Planning Commission Staff Report

February 22, 2017
Item 5.b.

SUBJECT: P16-0916

PURPOSE: Application for Design Review approval to construct an approximately 4,800-square-foot, two-story, single-family residence with an approximately 767-square-foot attached garage

Figure 3: Site Plan

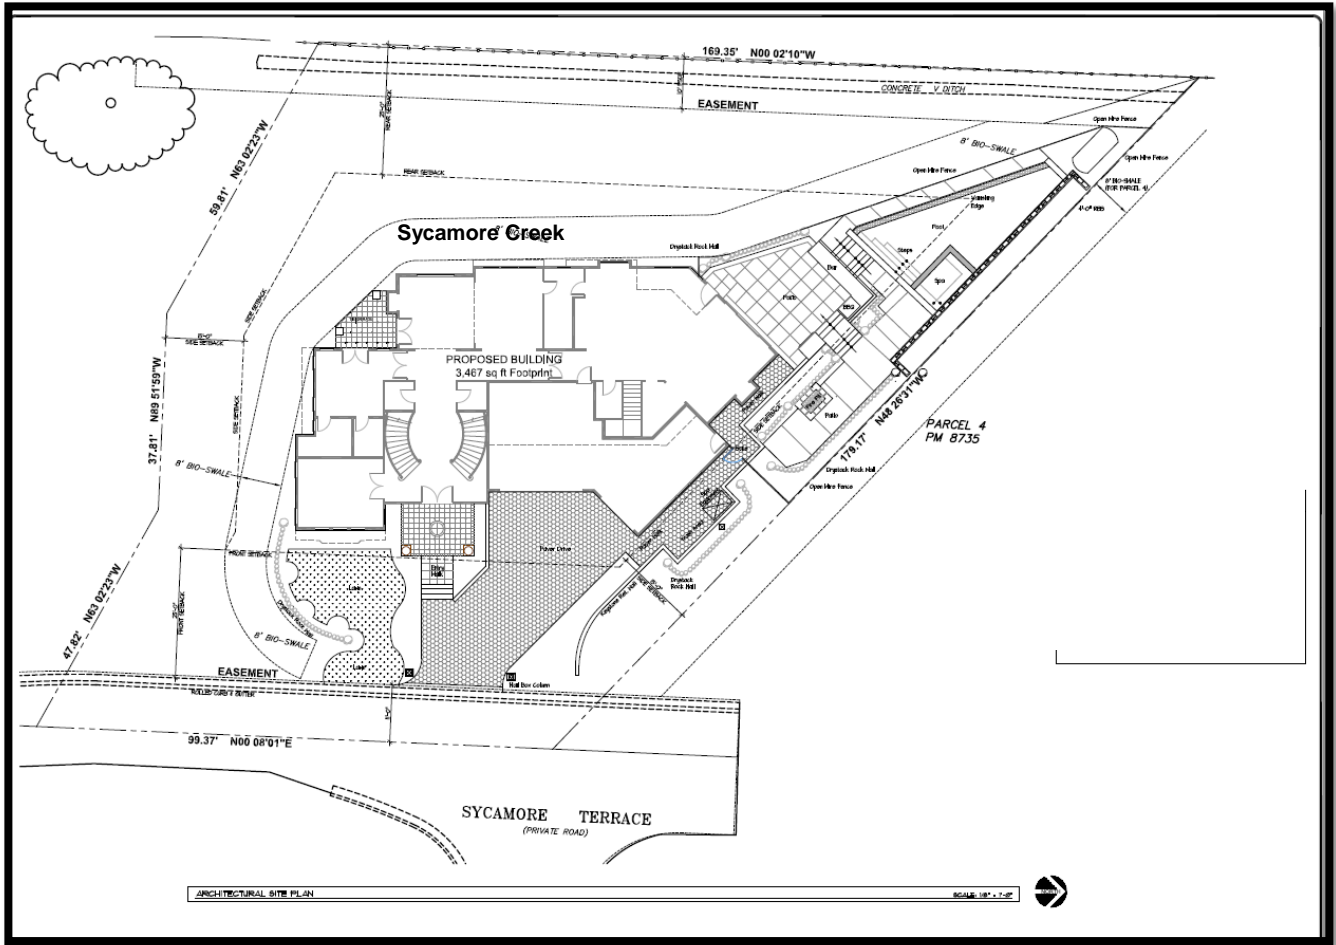
The site was pre-graded when the subdivision improvements were installed, creating a narrow building pad area with slope banks sloping downward to the west and south and upward to the north. Grading is proposed to provide driveway access from Sycamore Terrace and for the pool and spa located to the northwest of the proposed home. The proposed home meets the required setbacks including the required setback from Sycamore Creek. Please see Figure 3 for the proposed site plan.
